# Silicon Errata and Data Sheet Clarifications

## ATtiny3216/3217

## Introduction

**Figure 24-1. USART Block Diagram**

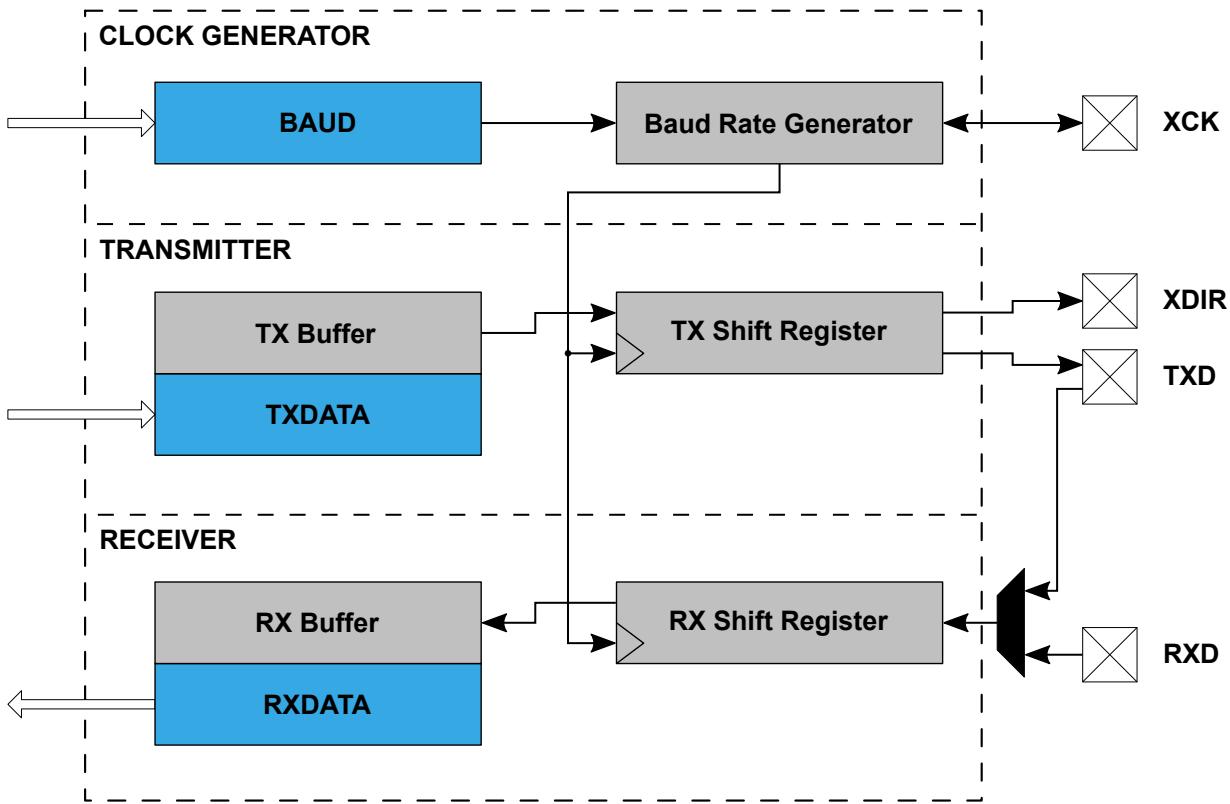
The block diagram is missing that USART TX is double-buffered from *Figure 24-1. USART Block Diagram* in the data sheet. The figure below shows the added **TX Buffer**.

The transmitter consists of a **two-level** write buffer.

The data transmission is initiated by loading the **Transmit Data (USARTn.TXDATAH and USARTn.TXDATAH)** registers with the data to be sent. The data in the **Transmit Data registers** are moved to the **TX Buffer** once emptied and then to the Shift register once it is empty and ready to send a new frame.
